1 November 2024

## Kingston Bypass Duplication and Algona Road Roundabout upgrade Submission to Parliamentary Standing Committee on Public Works

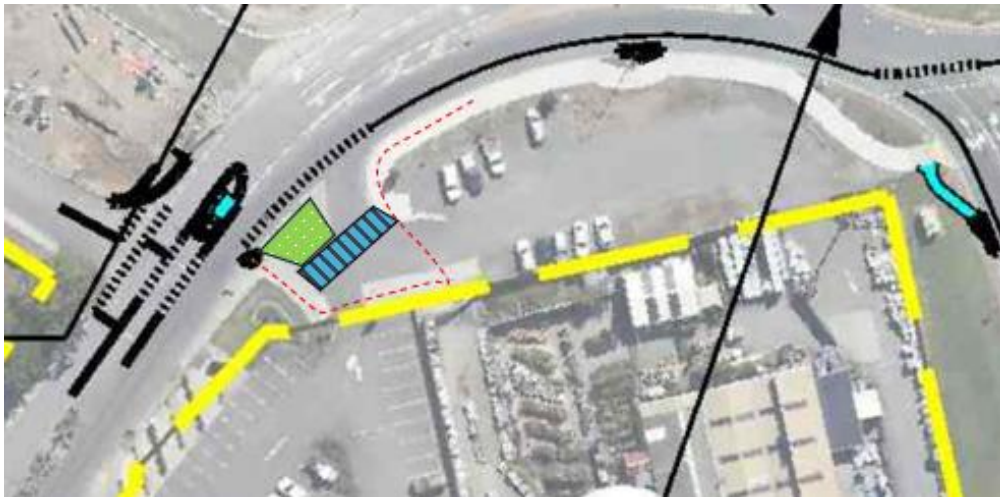
- **Pedestrian overpass across the Channel Hwy** – It is excellent to see this improvement from the original design which had no grade-separated crossing on the Channel Hwy. The pedestrian overpass needs to be 3.5m in width which leaves a shared path operating space of 3.0m with 25cm clearance on either side from railings (which can catch handlebars). The overpass should have DDA compliant grades of 1:14. Corners on the path should be rounded curves rather than sharp angles.
- **Shared path on north side of Kingston Bypass** – Ideally this path will have a direct and easy transition onto it at Maddocks Road. An exit ramp should be included to provide a direct transition from the sealed shoulder to the path. See purple arrow on diagram. Corners on the path should be curved with a generous radius and not sharply angled.

The section of Huntingfield Ave by the Park and Ride is extremely hostile to people trying to cross the road to travel to the Park and Ride by foot, bicycle or scooter, particularly during peak periods. It is good to see a pedestrian refuge included as it was omitted from the original Park and Ride plans, despite requests from multiple submissions. It needs to be wide and deep enough to accommodate the length of a bicycle and more than one person in the refuge at a time.

The pathways connecting to the Park and Ride are extremely poorly aligned and need to be remedied as part of this project. It's one of the worse examples of poor design I have ever seen for a pathway project intended to make it easier for people to access public transport. The paths are indirect and have convoluted alignments and multiple unnecessary driveway crossings (red dotted line on diagram). A direct wombat crossing that gives priority to path users should be constructed across the driveway entrance to Mitre 10. Ideally the exit from the carpark by the pedestrian refuge should be closed and cars are directed through the Mitre 10 carpark to the exit further south on Huntingfield Ave. This would make this messy intersection more straightforward and improve amenity and safety for people walking and riding.
